**Site Formation and Infrastructure Works
for Public Housing Development near Tan Kwai Tsuen,
Yuen Long – Investigation, Design and Construction**

**FINAL PRELIMINARY
ENVIRONMENTAL
ASSESSMENT REPORT**

199086/BIN/103/Issue 1
March 2023

RESPONSE TO COMMENTS RECORDS

Drawing No. Figure 5.1

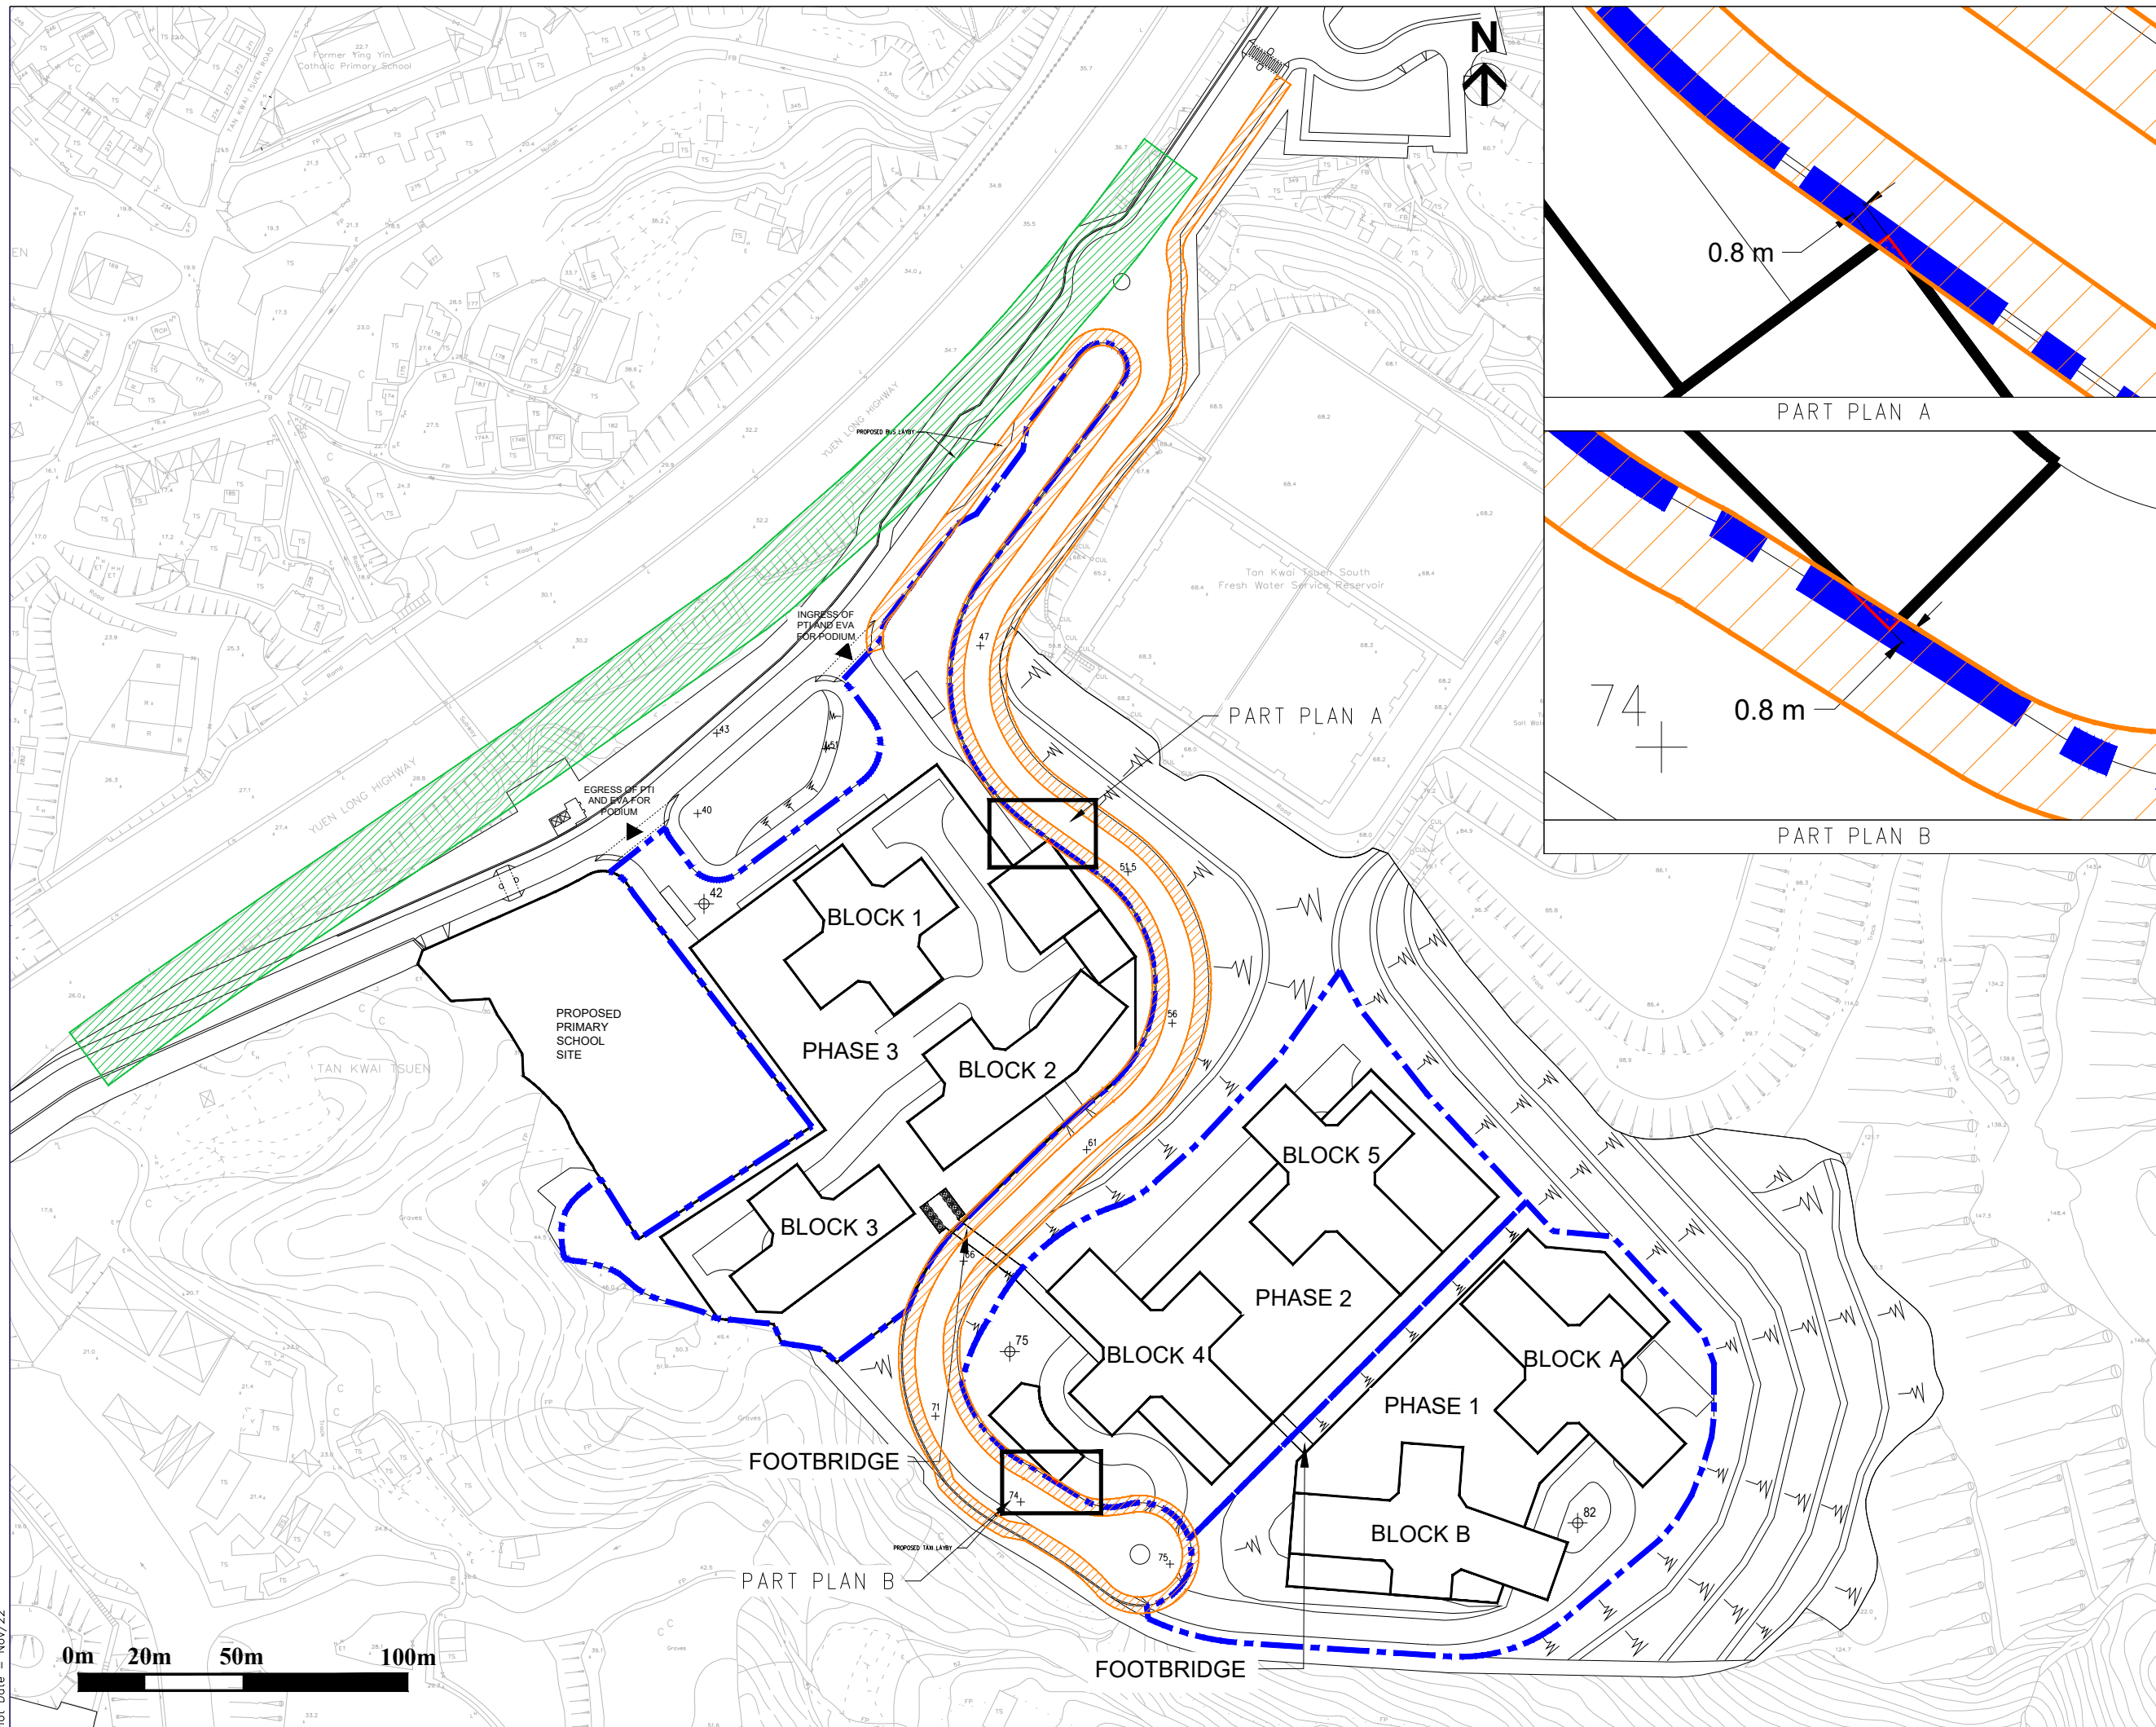
<p>4. <u>Section 4.2.4</u></p> <p>Please add the following wording: <i>"With the implementation of appropriate at-source mitigation measures by owner of proposed fixed noise source (i.e. WSD), no adverse fixed noise impact from the planned fixed noise source is anticipated."</i></p>	<p>Section 4.2.4 has been revised.</p>
<p>5. <u>Section 5.1.1 and Figure 5.1</u></p> <p>The consultant has based certain findings on PER report under Agreement No. CE92/2017 (CE). Referring to the PER Section 4.5.10 on Fixed Plant Noise Impact, the Consultant stated that the ingress and egress to the PTI has no direct line of sight to NSRs (refer attached extracted from PER). This appears not the case with the current layout. Please demonstrate no line of sight by sections.</p> <p>Some portion of PTI is outside the covered podium area. To avoid misunderstanding, please seek explicit confirmation from EPD</p>	<p>Potential noise impacts along the ingress and egress outside the covered podium area have been addressed in Section 5.1.2. The ingress and egress have been indicated in Figure 5.1 as well.</p>

Drawing No. Figure 6.1

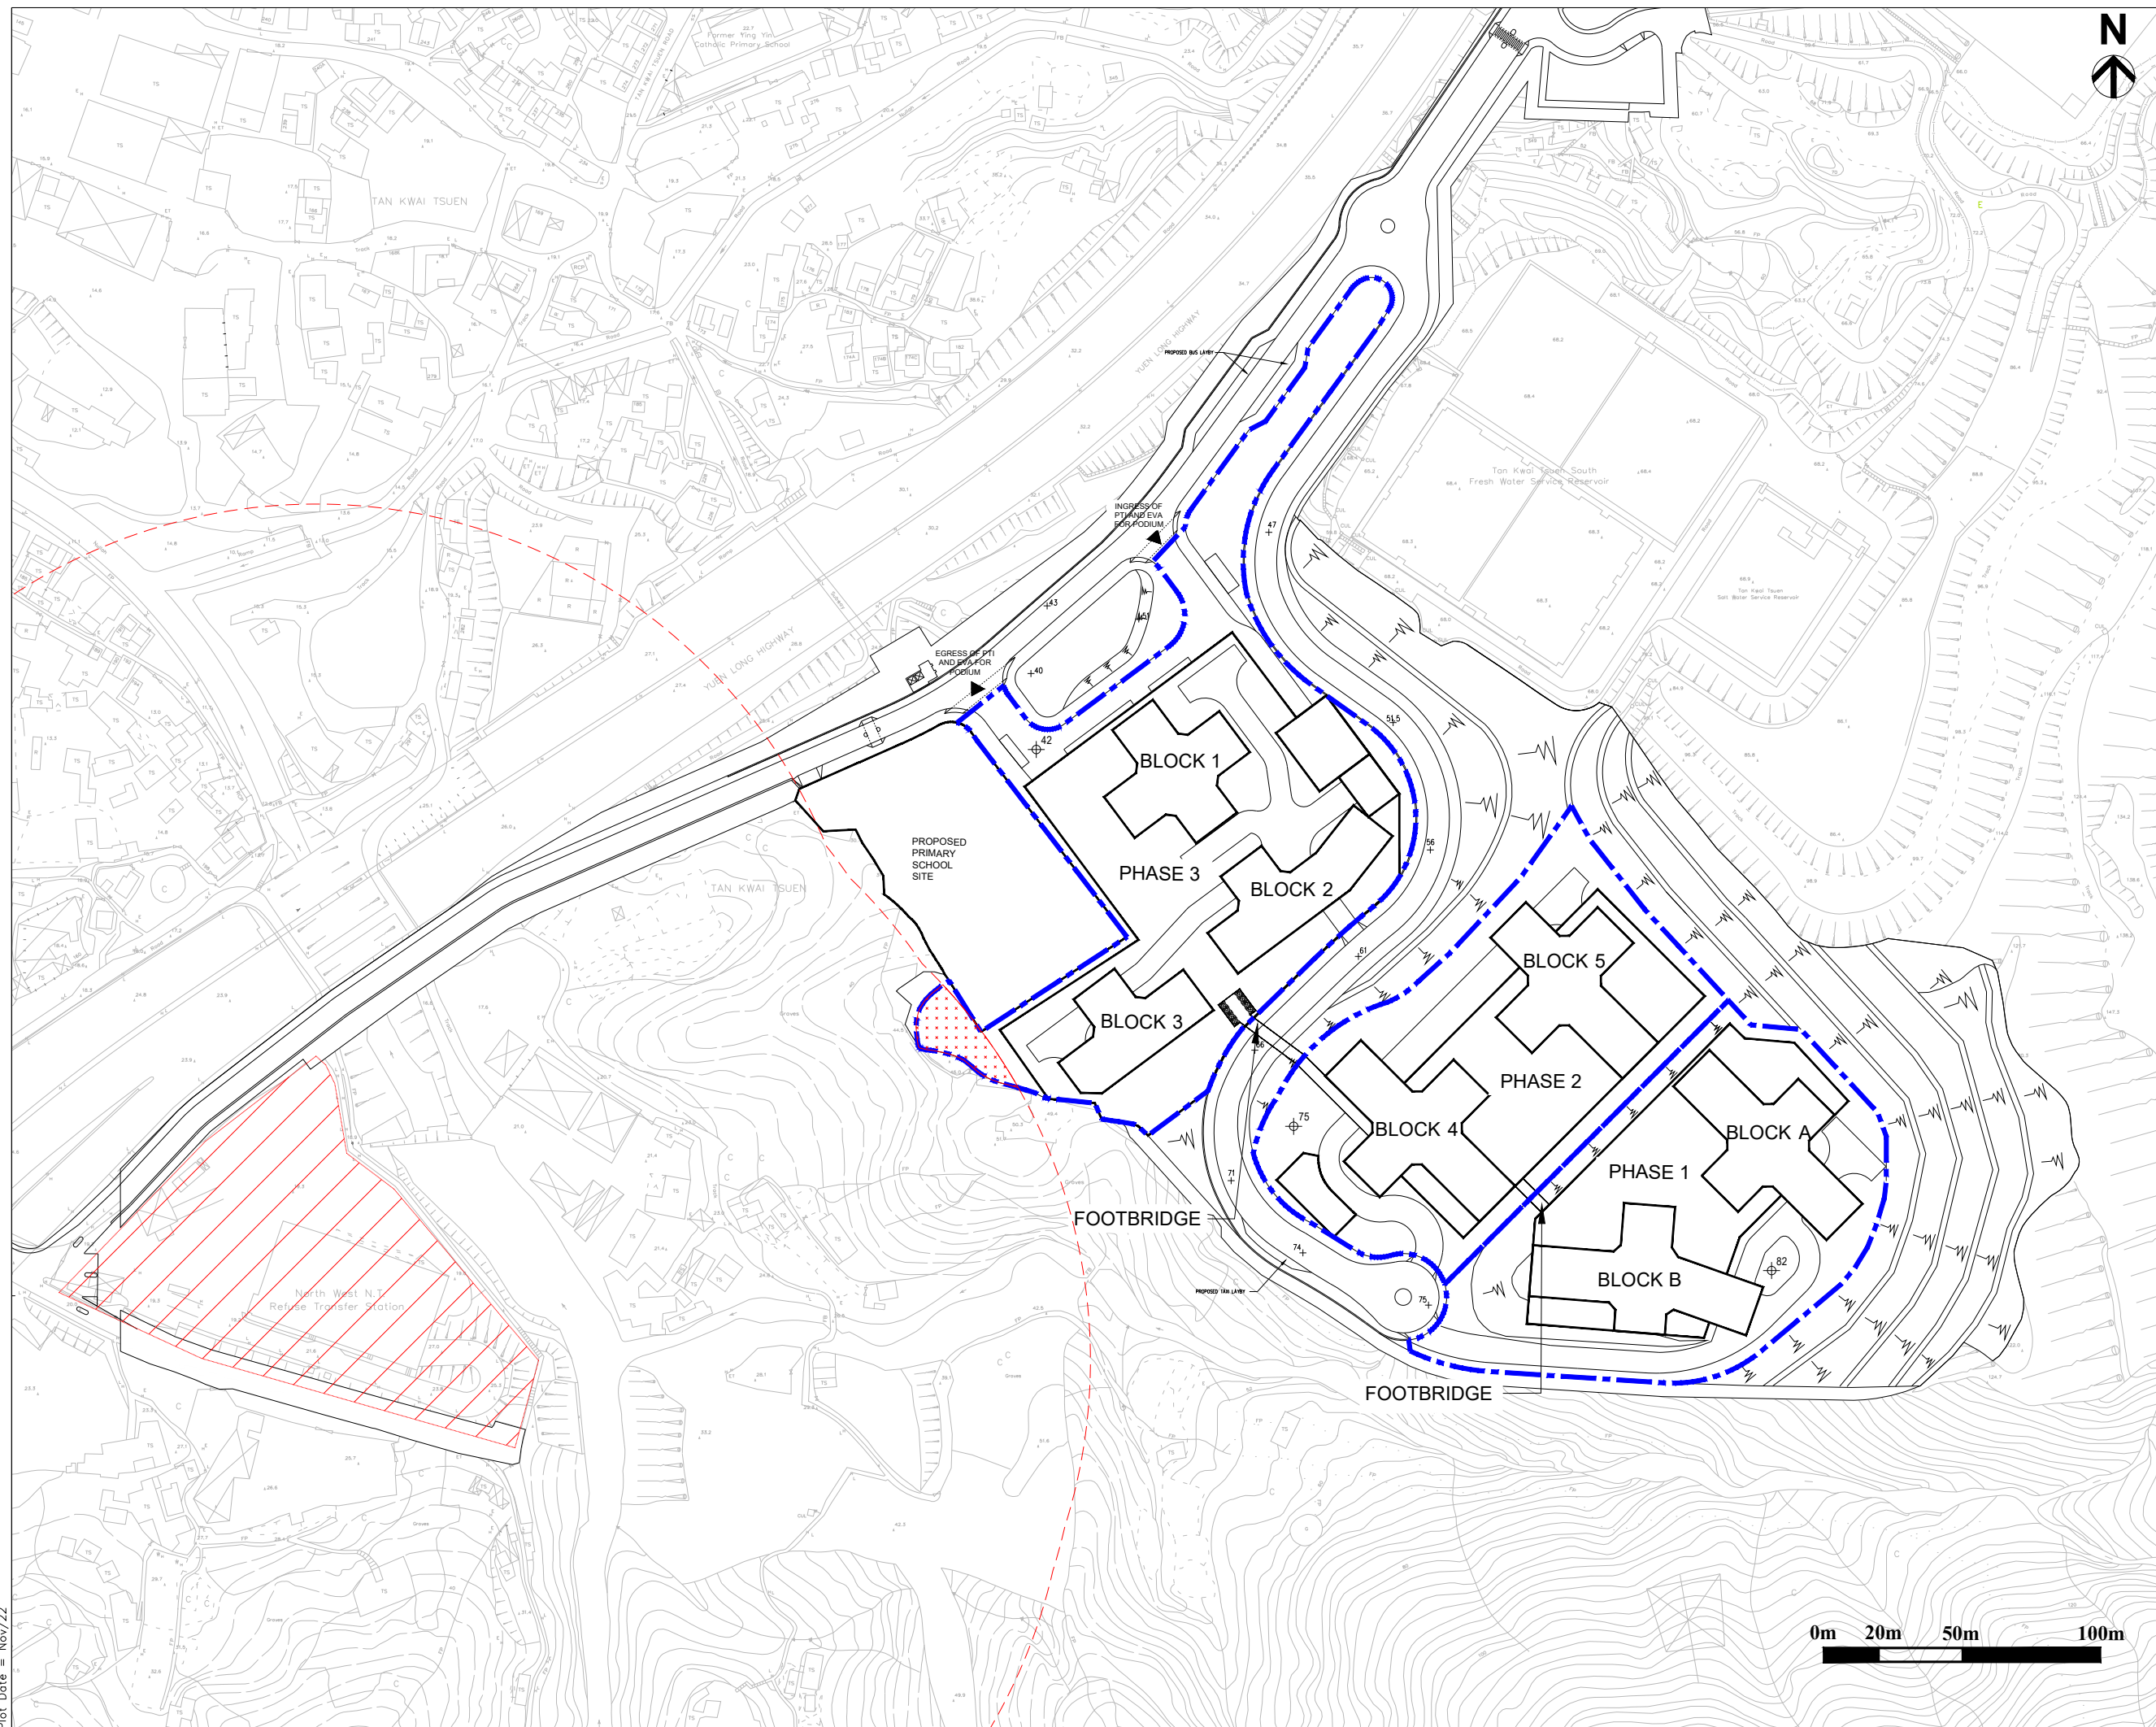
9. Figure 6.1	
(a) Please show the buffer zone for the whole section of the proposed access road leading to the end of the proposed development in Figure 6.1 to demonstrate that there will be no nearby ASRs including the air sensitive use of the proposed development within the buffer zone.	Figure 6.1 has been revised to show the buffer zone for the whole section of the proposed access road leading to the end of the proposed development.

(b) Please clarify if the proposed access road in between Yuen Long Highway and the proposed housing site is not covered under this project. Otherwise, the buffer zone for the whole section of this proposed access road should be shown in the figure.	Please note that said proposed access road is not covered under this Planning Application.

(c) Please provide a remark in Figure 6.1 to state clearly that no air-sensitive uses including openable window, fresh air intake and recreational use in the open space is allowed within the buffer zone.	A remark has been included in Figure 6.1.
